Subject: Certificate of Compliance No. 5862; Docket No. 71-5862

This submittal is in response to your letter FCTC:CEW 71-5862 dated July 25, 1985 with an enclosure entitled "Teledyne Energy Systems, Model No. Sentinel 100F, Docket No. 71-5862 dated July 25, 1985."

STRUCTURAL AND THERMAL
EVALUATION
OF SENTINEL 100F

INSD-3080

FIGURE E.1. RTG TO PALLET MOUNTING HARDWARE

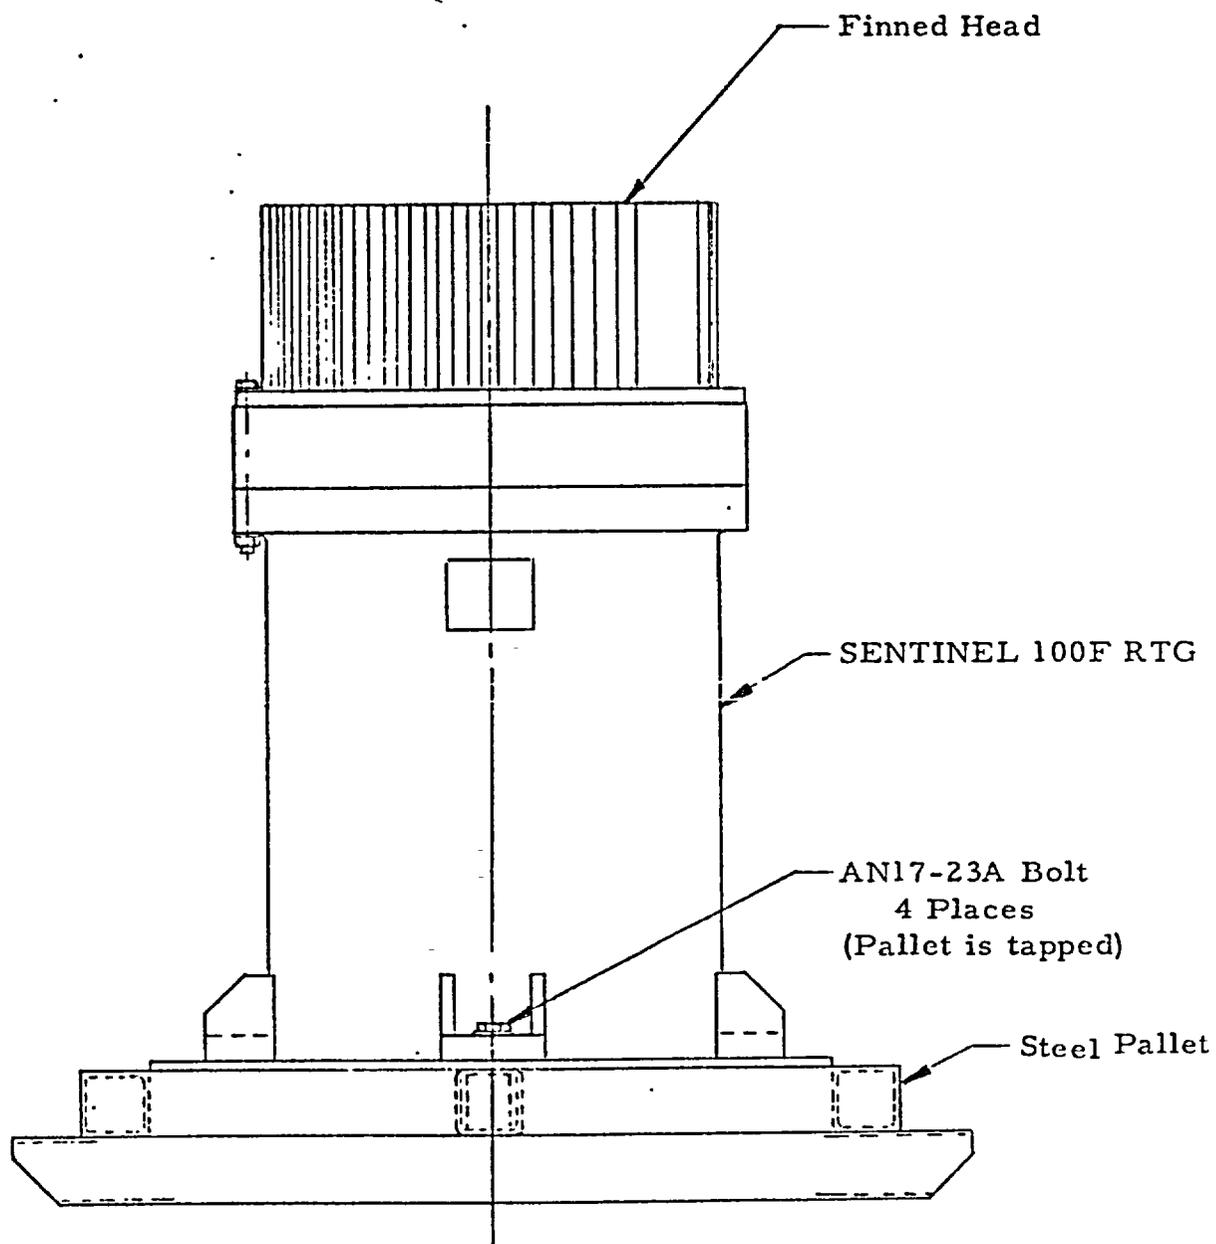
The RTG is bolted to a steel pallet assembly for shipment using the hardware shown in Figure E.1. Hardware is torqued to 300 ± 30 foot pounds.
